APPLICATION NO.	FILING DATE	FIRST NAMED INVENTOR	ATTORNEY DOCKET NO.	CONFIRMATION NO.
10/600,379	06/20/2003	Steve B. Taylor	2236.001	7549

Office Action Summary

DETAILED ACTION

Patent 5697320 (see marked-up figures below).

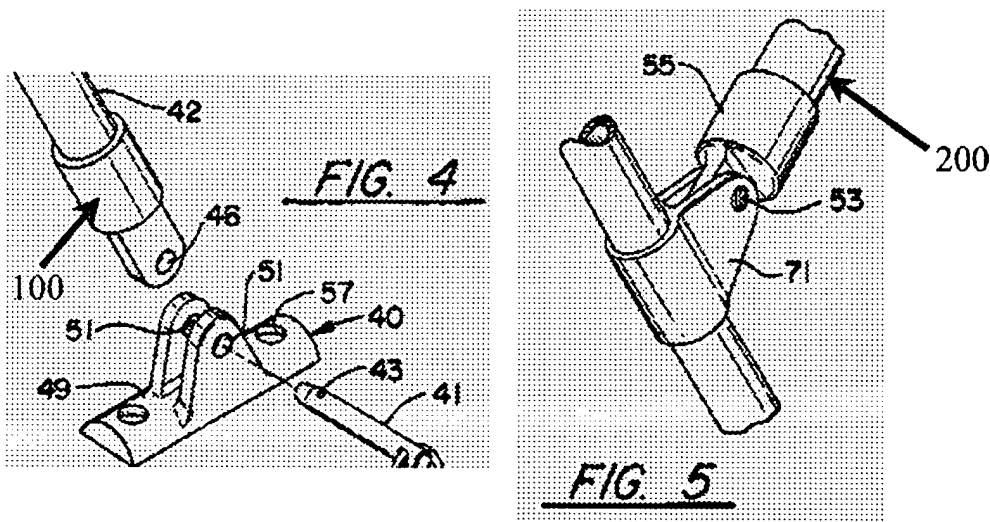
Claims 1-3 are rejected under 35 U.S.C. 102(b) as being anticipated by Murray U.S.

Claim 1. Murray discloses (figs. 1, 4, 5) a variably positionable coupler mountable on a curved surface, comprising: a base (40) formed with an upper side and a lower side, wherein the lower side is a substantially flat planar surface; means (57) for mounting the base on the curved surface; a tub (100) adjustably connectable to the base; a plug (42, 71) repositionably attachable to the tub; a neck (55) rotatably insertable in the plug, wherein the neck is formed for securing a

shaft (200) to the neck; and a clevis mechanism (clevis connection between 55 and 71) slidably and demountably engageable with the plug and the neck. (Note that while the Murray curved surface does not curve at its point of contact with element 40, it does curve elsewhere and is thus a curved surface within the broadest reasonable interpretation of the claim language).

Claim 2. Murray discloses opposing yokes (tab portions of 40 receiving 41) monolithically extending at substantially right angles from the upper side of the base.

Claim 3. Murray discloses one or more bores (51) formed in the base with a proximal end and a distal end, and further wherein the one or more bores are shaped for removable engagement with a bolt (41). The word "bolt" is taken by the examiner to mean, "a metal rod or pin for fastening objects together" in accordance with Merriam-Webster's Collegiate Dictionary Tenth Edition.
